Access Compliance Report

Public Rights-of-Way

(Curb Ramps)

Intersection ID: 22230	Main Street: N_SARDIS_VIEW_LN	Cross Street: SARDIS_RD	Location: SE
ADA ID: A5BA11E40BA0	Ramp Type: Directional1	Initial Pass/Fail: Fail	Overall Compliance: No
Codes/Mitigation Info/Possible Solution		Field Measurements/Component Compliance	
Severity Score: 25

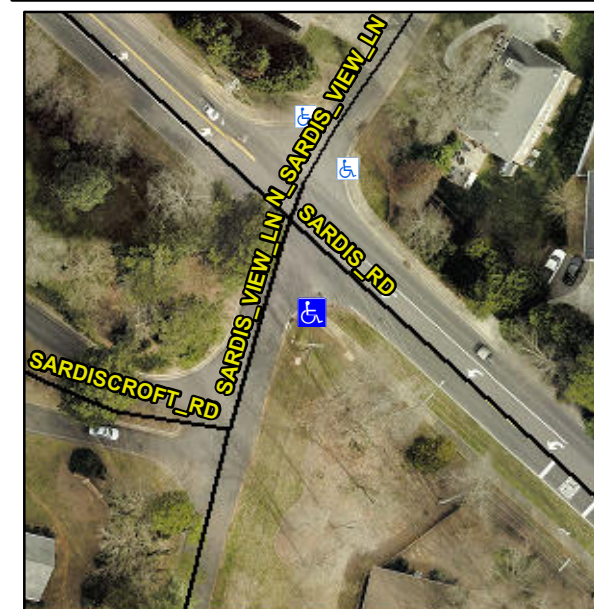
R304.2.2, R304.5.3

Compliance	Description	Data	Compliance	Description	Data
N/A	Ramp Length (in)	36.0	N/A	Grade Break?	N/A
Yes	Ramp Width (in)	69.0	N/A	Grade Break Slope (%)	0.0
No	Ramp Slope (%)	10.3	N/A	Grade Break XSlope (%)	0.0
No	Ramp XSlope (%)	6.3			
N/A	Flare Type LT	N/A	N/A	Flare Type RT	N/A
N/A	Flare Slope LT (%)	N/A	N/A	Flare Slope RT (%)	0.0
N/A	Flare Traversable LT?	N/A	N/A	Flare Traversable RT?	N/A
N/A	Landing Length (in)	0.0	N/A	DWS Provided?	N/A
N/A	Landing Width (in)	0.0	N/A	DWS Contrast?	N/A
N/A	Landing Slope (%)	0.0	N/A	DWS Length (in)	N/A
N/A	Landing X Slope (%)	0.0	N/A	DWS Full Width?	N/A
N/A	Landing Curb? (Y/N)	N/A	N/A	DWS Offset LT (in)	N/A
N/A	Shared Landing?	N/A	N/A	DWS Offset RT (in)	N/A
N/A	Gutter Ponding?	0.0	N/A	Gutter Slope (%)	N/A
N/A	Gutter Lip Ht (in)	0.0	N/A	Gutter X Slope (%)	N/A
N/A	Painted X Walk1?	No		Road Slope (%)	1.2
	X Walk 1 Direction	To NW		Road X Slope (%)	3.5
	X Walk 1 Width (in)	N/A		Clear Space?	N/A

X Walk 1 Slope (%)	1.2	N/A	Clear Space to XWalk (in)	N/A
	X Walk 1 X Slope (%)	3.5	N/A	Storm Grate/Utility Hazard?	N/A
N/A	Ramp inside XWalk1?	N/A		Storm Grate/Utility Type	
N/A	Any Obstructions?	N/A			N/A
	Obstruction Type		Yes	Surface Condition? (G/P)	Good
			N/A	Curb Slope (%)	21.9

Remove & Replace Entire Ramp.
